**2020 CMOM PACKAGE 2B PROJECT
Solicitation No. CO-00519
Job No. 21-4511**

**ADDENDUM NO. 1
September 29, 2022**

SSORP CMOM PACKAGE 2B
PLAN & PROFILE
8" SANITARY SEWER MAIN
(SITE 6)

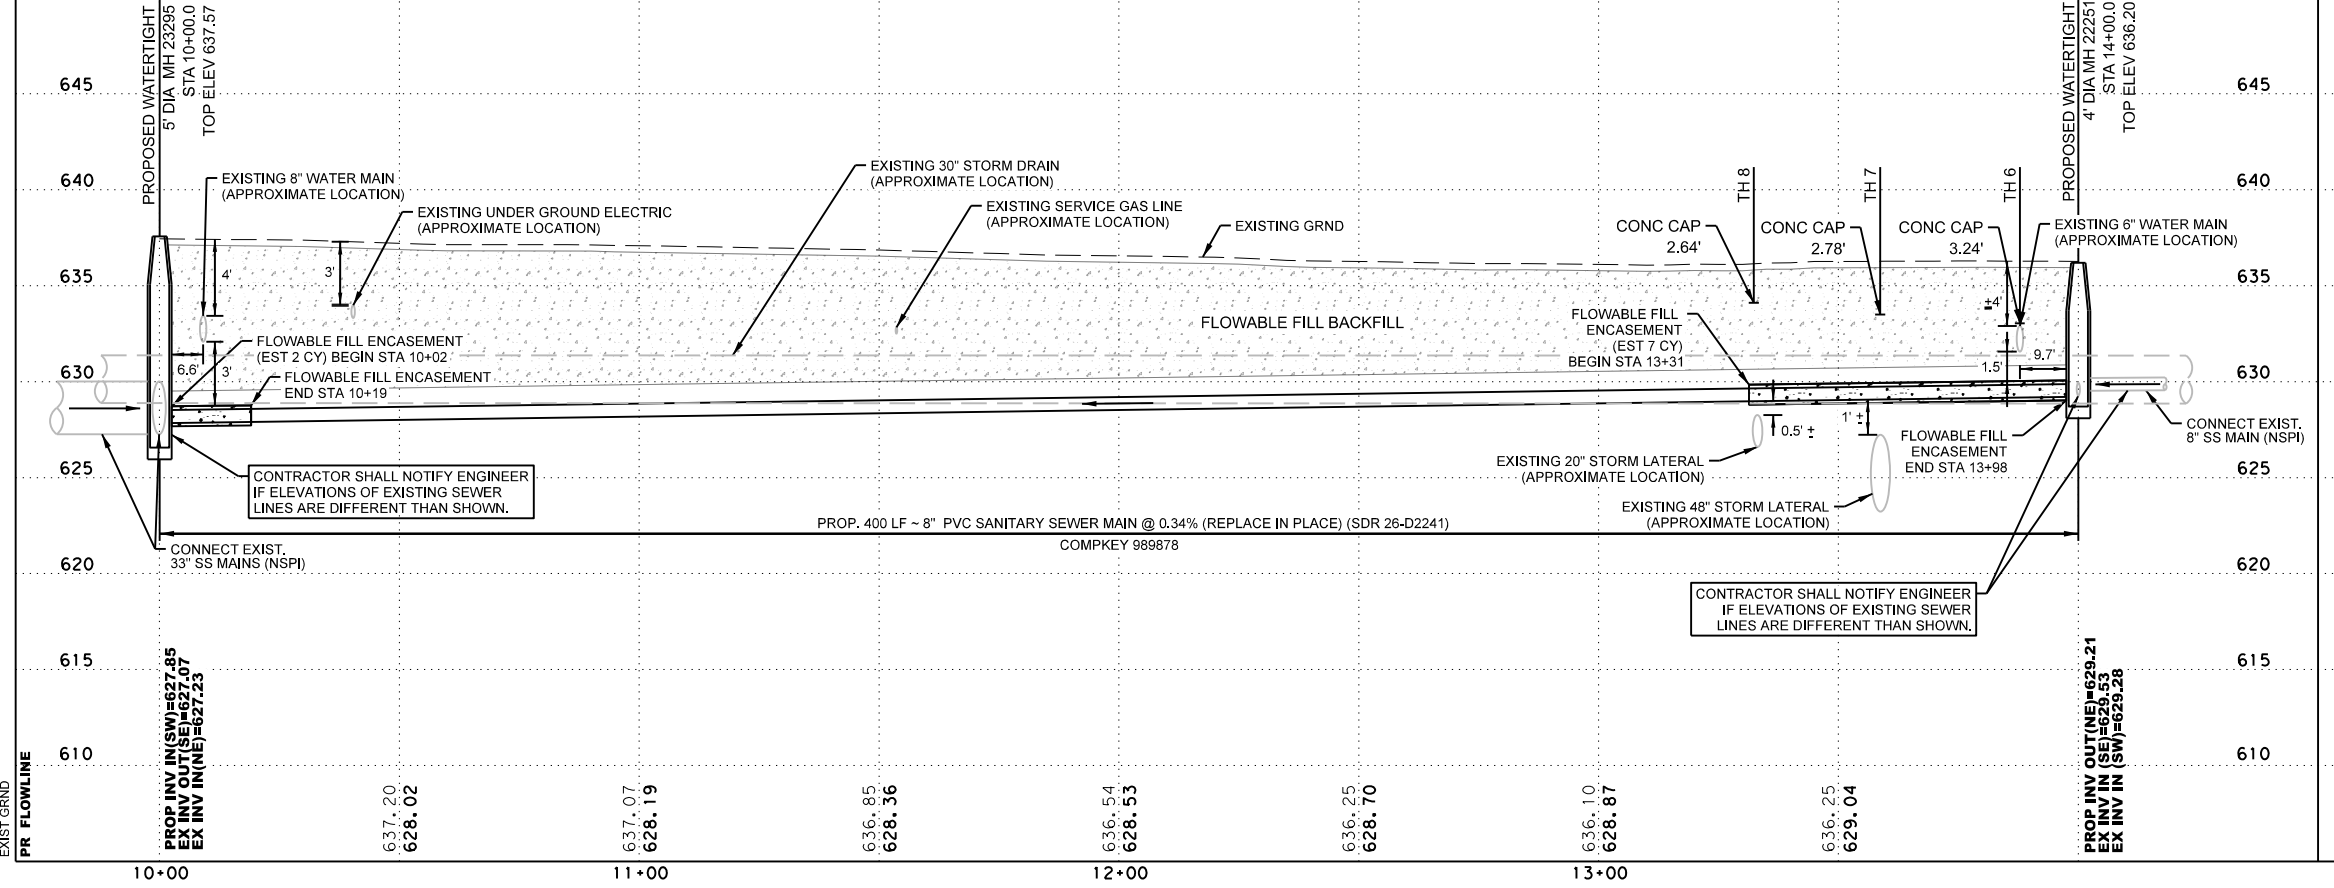
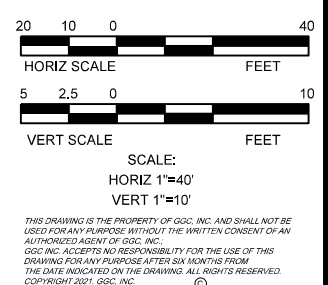
1. Replace sheet 5 with attached sheet. Revised sheet includes corrected TxDOT ROW limits to Site 6 - Plan and Profile.

REVISED 9/21/22
 TXDOT ROW LIMITS

2020 CMOM PACKAGE 2B
**PLAN & PROFILE
8" SANITARY SEWER MAIN
(SITE 09)**

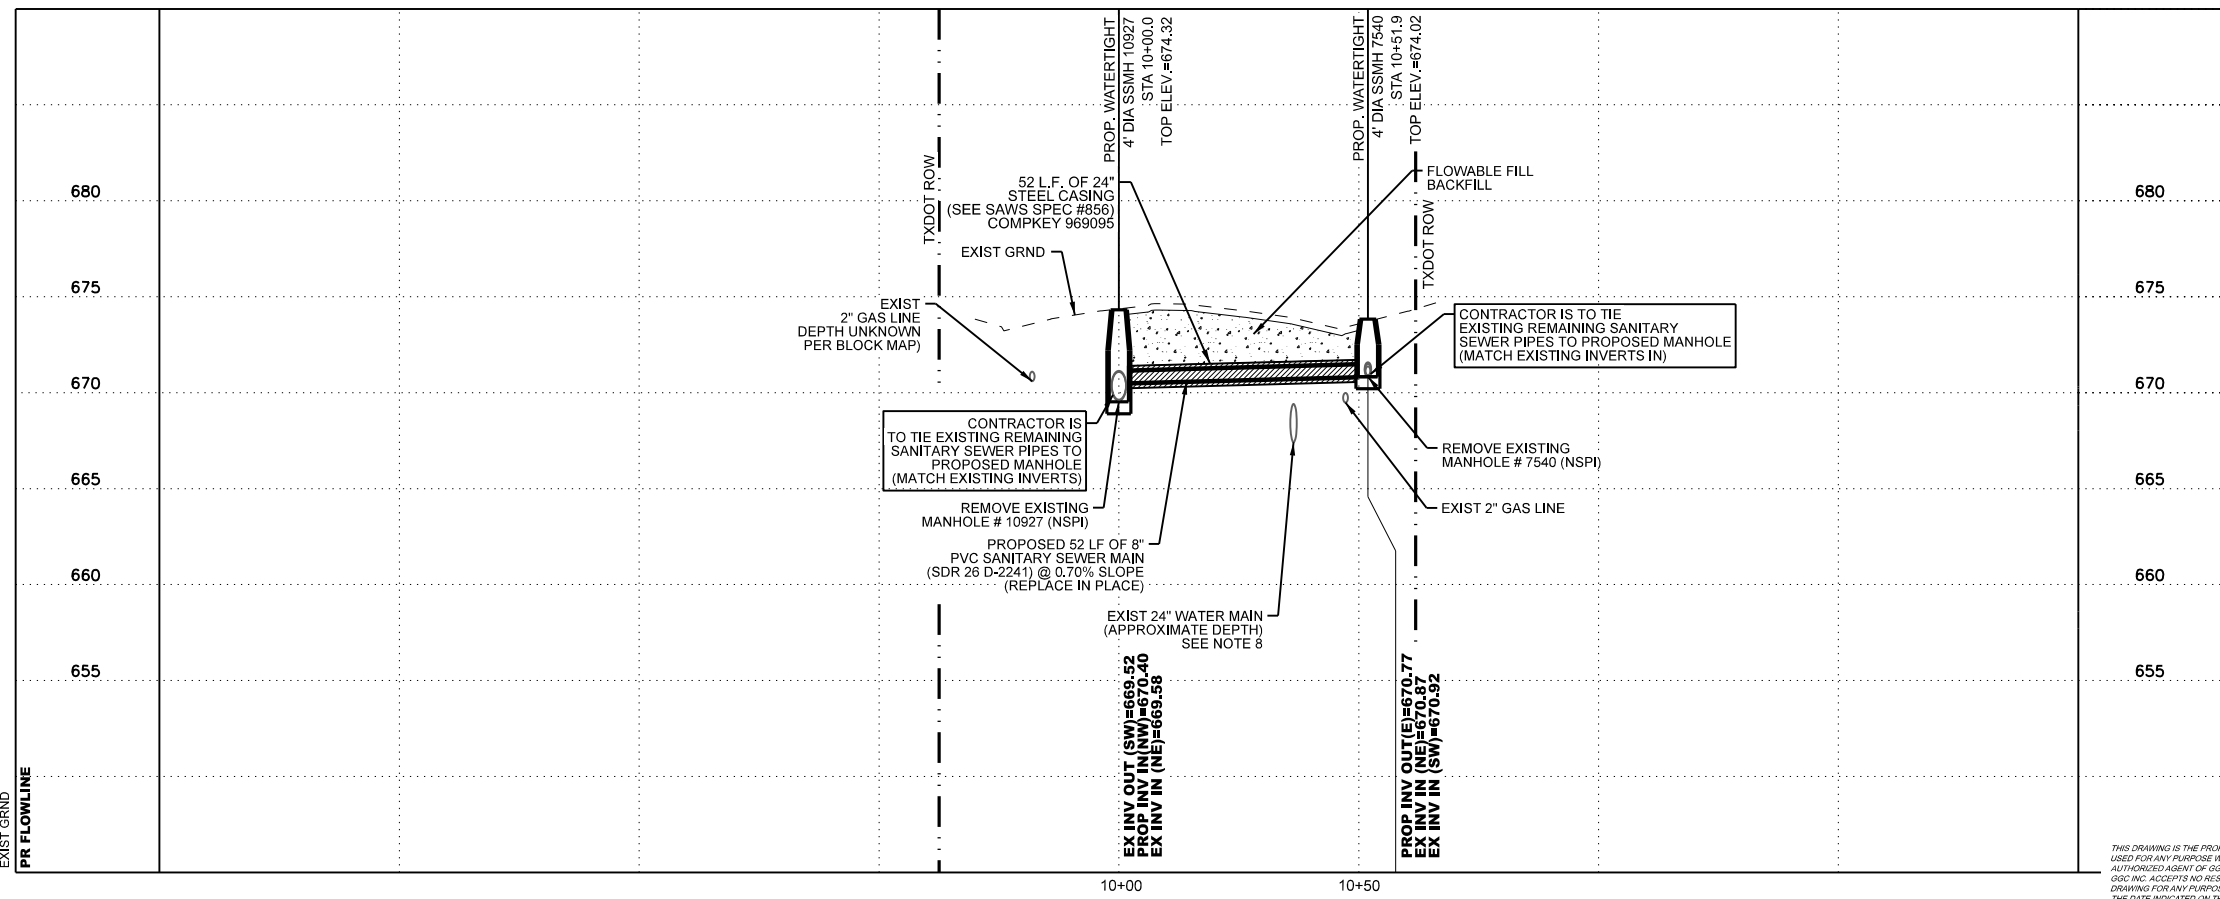
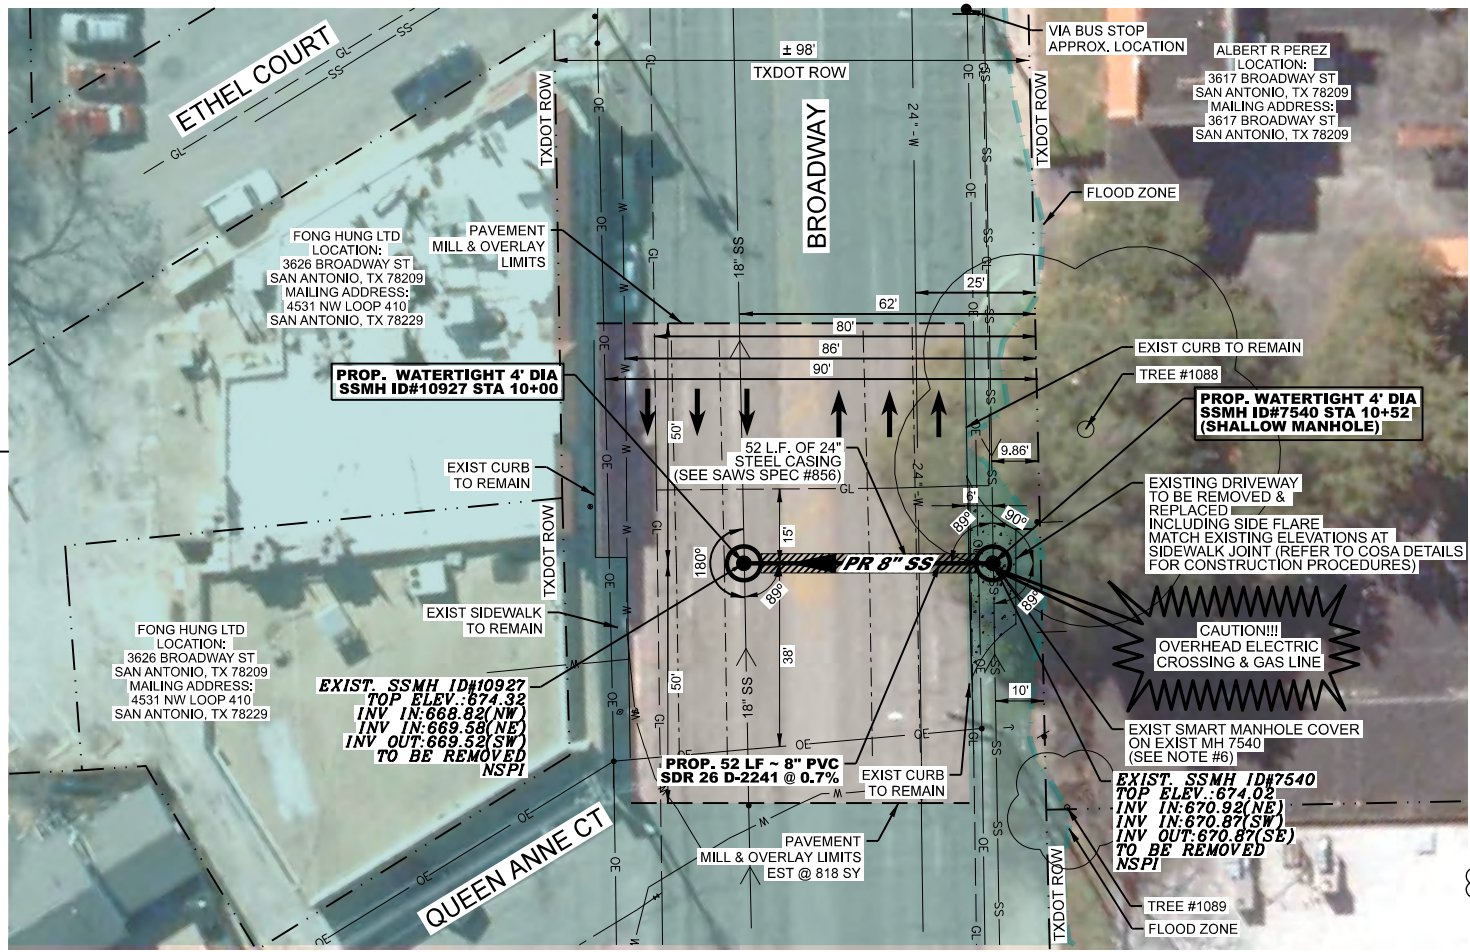
**2. Replace sheet 8 with attached sheet. The following note to Site 09 - Plan and Profile was added:
"9. Installation of the 52 LF of steel casing and carrier pipe is inclusive for item 856."**

- CONTRACTOR IS TO VERIFY ELEVATIONS OF WATER MAIN & GAS MAINS PRIOR TO WORK COMMENCEMENT. CONTACT ENGINEER IF ELEVATION IS DIFFERENT THAN SHOWN.
- INSTALLATION OF THE 52 LF OF STEEL CASING AND CARRIER PIPE IS INCLUSIVE FOR ITEM 856.
